Public Input No. 44-NFPA 88A-2024 [Global Input]

C Sample Ordinance Adopting NFPA 88A

Public Input No. 73-NFPA 88A-2024 [Section No. 6.4]

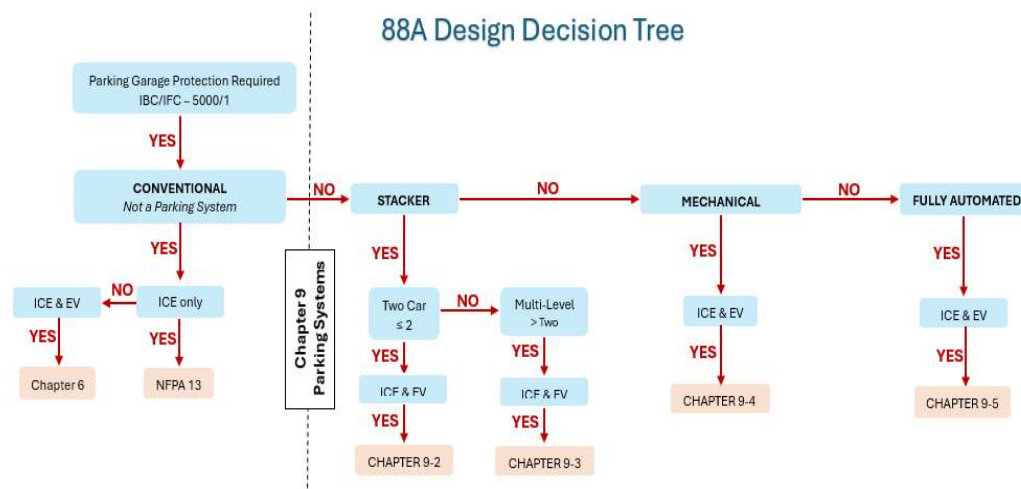
The requirement to provide sprinkler protection for all open parking structures was not warranted even though the committee accepted this change during the last cycle. The cost of installing the multiple dry systems per floor, which is almost always the case based on the NFPA 13 installation requirements and the size of garages, and the costs of maintenance for these systems was not technically justified. The Cost Estimating group in VA has estimated costs to be as much as \$8.00 per square foot just for the capital costs and that doesn't cover the testing and maintenance costs of the dry pipe systems.

follow NFPA 13, not NFPA 13R, when going outside the dwelling unit, so reference to NFPA 13R doesn't provide any useful information.

Resolution: The committee did not agree with the submitter. The decision to add the requirement for sprinklers in open parking structures for the 2023 edition was based on research data from Phase I of the Fire Protection Research Foundation. The committee currently has an additional report, Phase 2, which adds significant data in the literature review that substantiate the fire risk in all parking structures, including open parking structures.
